BICESTERBUG

Submissions on proposed housing in NW Bicester

21/01630/OUT

22 June 2021

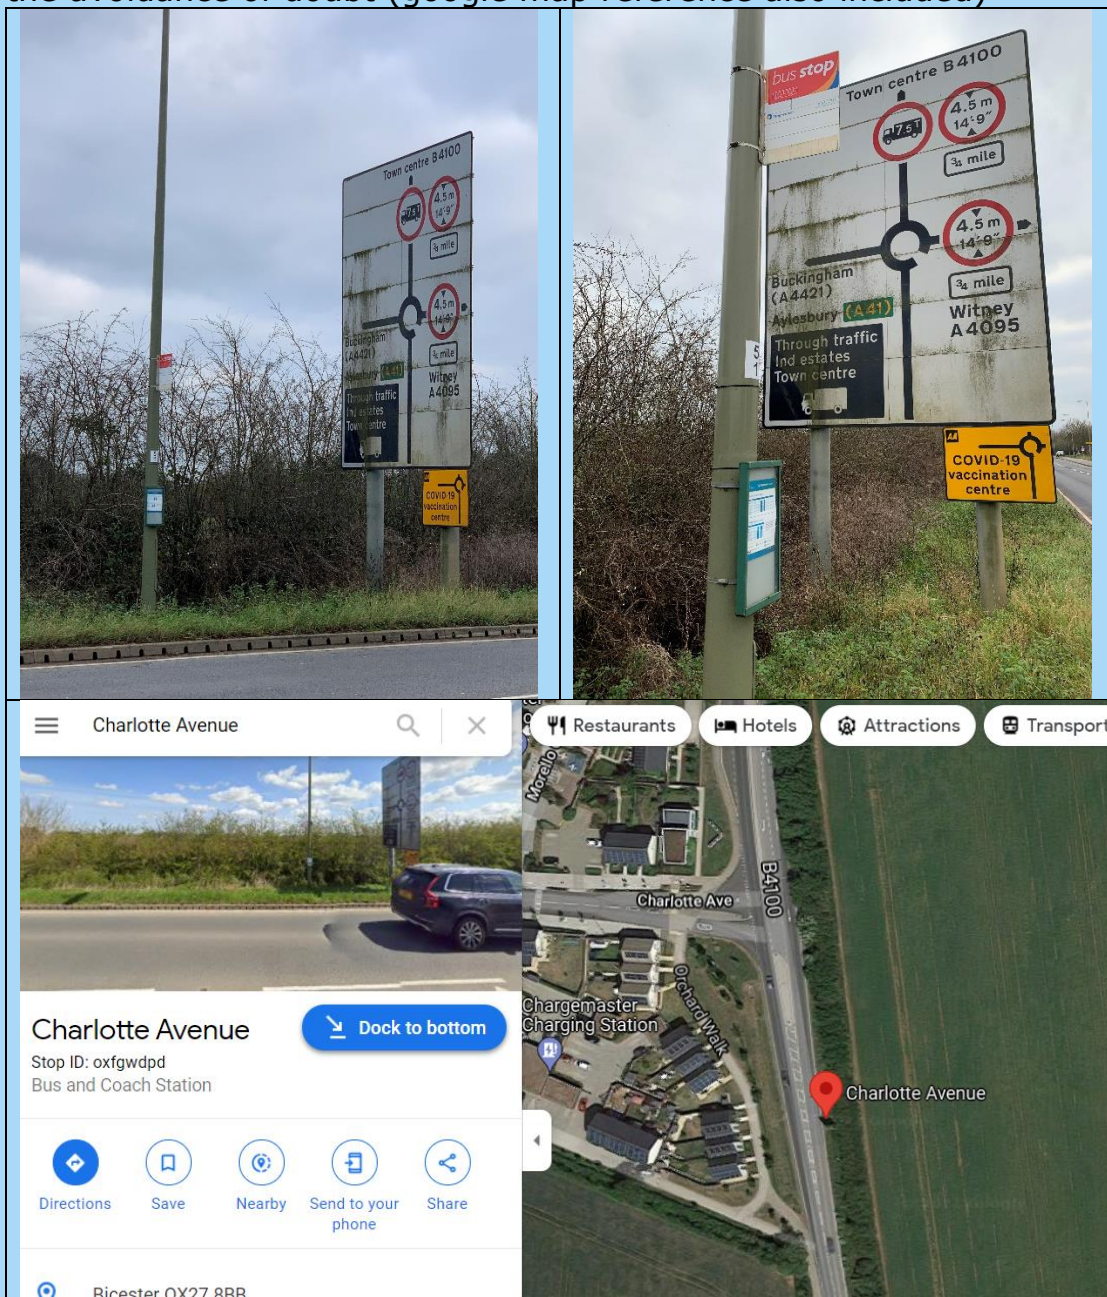
Section 5.7 is still incorrect in asserting that there is no bus stop on the eastern side of the B4100 the photograph below is included for the avoidance of doubt (google map reference also included)

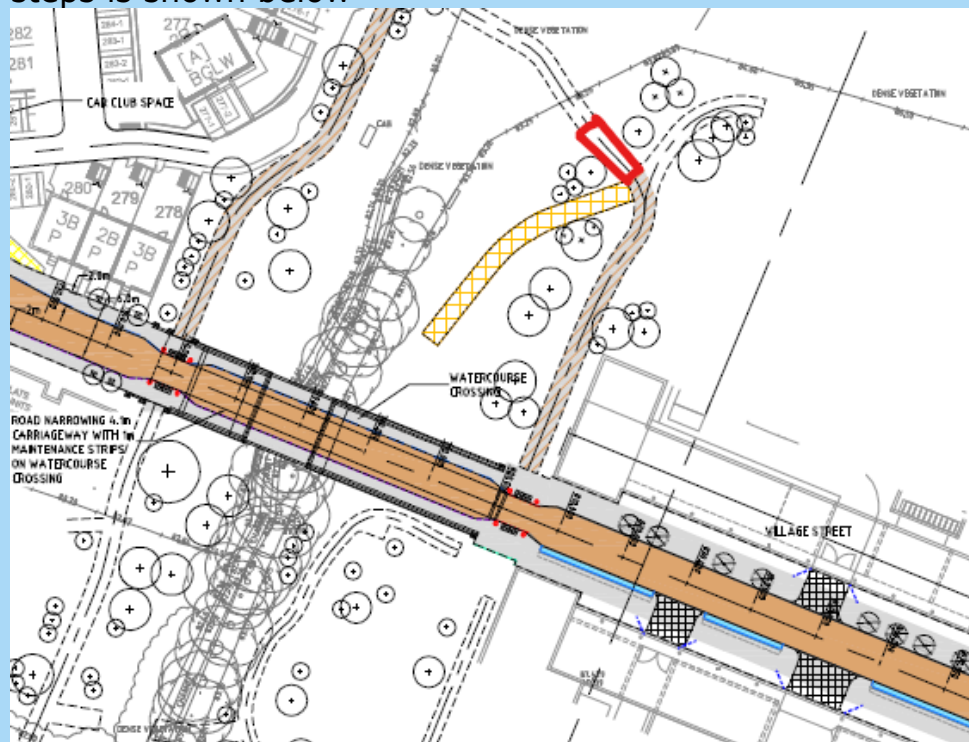
We welcome the conclusions that with the increased traffic flows the potential of the bridge to be a bottleneck and barrier to active travel (in turn driving up vehicle numbers still further) and that a solution needs to be found. We also note that in Item 4.2.8 it is asserted that the alternative to the spine road bridge via the foot bridge to the north is suitable for active travel. This is currently not the case due to the steps which make the route unsuitable for all users and would be inaccessible to bike users unable to dismount and carry a bicycle, such as the elderly, young and mobility impaired. The location of the steps is shown below
